# Access Compliance Report

## Public Rights-of-Way

Intersection ID: 10029465	Main Street: E_STONEWALL_ST	Cross Street: E_JOHN_BELK_RA	Location: NE
ADA ID: 232150726461	Ramp Type: PerpDiag	Initial Pass/Fail: Fail	Overall Compliance: No
Severity Score: 26.25			
Codes/Mitigation Info/Possible Solution		Field Measurements/Component Compliance

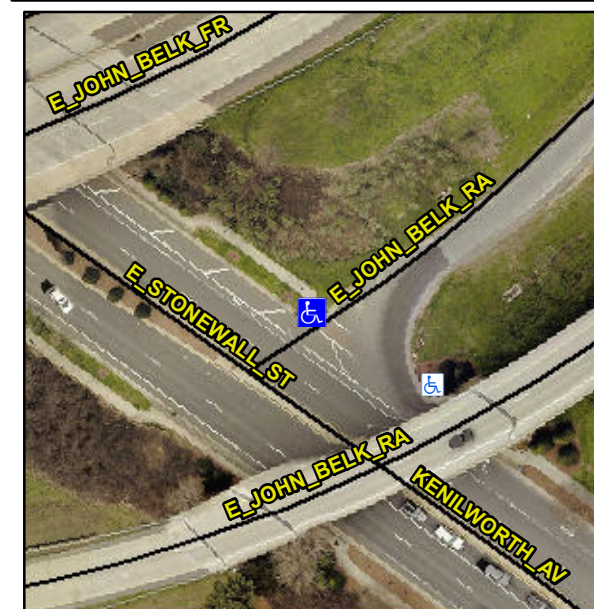
**Not Found, R304.2.2, R304.5.3**

Compliance	Description	Data	Compliance	Description	Data
N/A	Ramp Length (in)	78.0	No	Ramp Slope (%)	12.5
Yes	Ramp Width (in)	48.0	No	Ramp XSlope (%)	3.8
N/A	Flare Type LT	N/A	N/A	Flare Type RT	N/A
N/A	Flare Slope LT (%)	N/A	N/A	Flare Slope RT (%)	N/A
N/A	Flare Traversable LT?	N/A	N/A	Flare Traversable RT?	N/A
N/A	Landing Length (in)	N/A	N/A	DWS Provided?	N/A
N/A	Landing Width (in)	N/A	N/A	DWS Contrast?	N/A
N/A	Landing Slope (%)	N/A	N/A	DWS Length (in)	N/A
N/A	Landing X Slope (%)	N/A	N/A	DWS Full Width?	N/A
N/A	Landing Curb? (Y/N)	N/A	N/A	DWS Offset (in)	N/A
N/A	Shared Landing?	N/A			
N/A	Gutter Ponding?	N/A	N/A	Gutter Slope (%)	N/A
N/A	Gutter Lip Ht (in)	N/A	N/A	Gutter X Slope (%)	N/A
N/A	Painted X Walk1?	No	N/A	Painted X Walk2?	Yes
	X Walk 1 Direction	To SW		X Walk 2 Direction	To SE
N/A	X Walk 1 Width (in)	N/A	N/A	X Walk 2 Width (in)	97.0
	X Walk 1 Slope (%)	1.6		X Walk 2 Slope (%)	1.9
	X Walk 1 X Slope (%)	2.3		X Walk 2 X Slope (%)	0.6

**Remove & Replace Curb Ramp With Two New Directional Ramps or Equivalent.**
